Active Way Submission for WCC

7 October 2026

Executive summary - Community Concerns

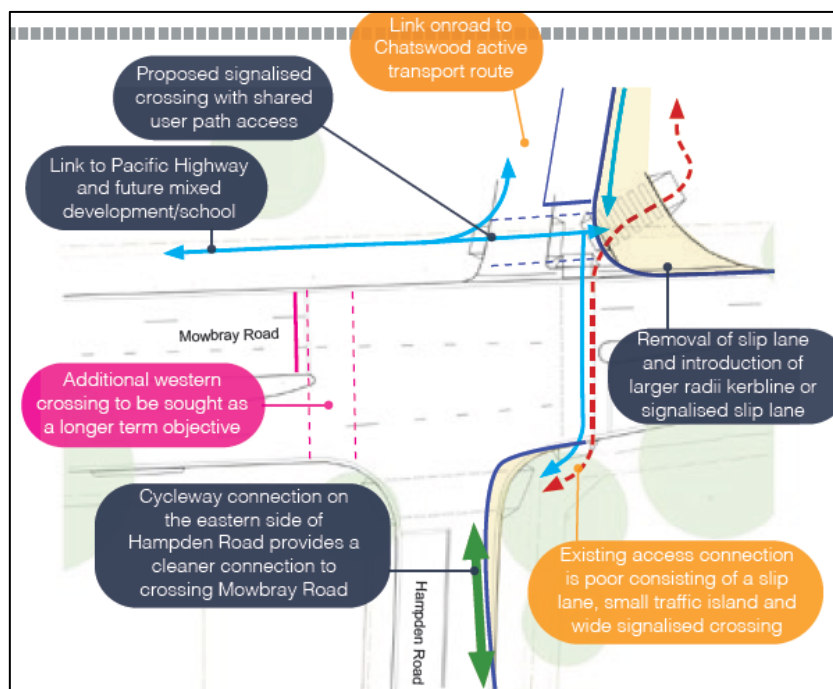
Locating the cycleway fully on the western side of Hampden Road would avert the need for a side-switch and associated "zig-zag" near Palmer Street, where the cycleway crosses from the eastern to western sides of Hampden Road.

The APA notes Council's current design places the cycleway on the eastern side of Hampden Road north of Palmer Street and shifts it to the western side south of Palmer Street, with a new wombat crossing immediately north of Palmer Street to facilitate that movement. Council states that the transition has been selected because of the steep grade and the configuration of the Brand Street roundabout, and that minimising transitions is intended to reduce cyclist-vehicle conflicts.

The APA accepts that these are legitimate engineering considerations. However, the proposed transition still warrants close scrutiny because it introduces a deliberate change in cyclist alignment at a location where users must read the road environment, adjust their line of travel and interact with a crossing. The issue is therefore not simply whether a transition can be constructed, but whether this particular transition is the most intuitive, direct and safest arrangement for the full range of cyclists using the corridor.

For this reason, the APA remains strongly of the view that the “zig-zag” itself should be treated as a design issue worthy of further review, rather than simply accepted as an unavoidable consequence of TfNSW’s preferred alignment. A continuous western-side alignment should be assessed alongside the current proposal, including its relative safety, directness, sight distance, grades, cyclist behaviour and vehicle interaction.

We note the study describes an “additional western crossing to be sought as a longer-term objective” (highlighted below in pink).

The APA therefore requests that Council clearly explain why a continuous western-side cycleway between Mowbray Road and Brand Street was not preferred and provide the comparative safety and operational assessment underpinning that decision.
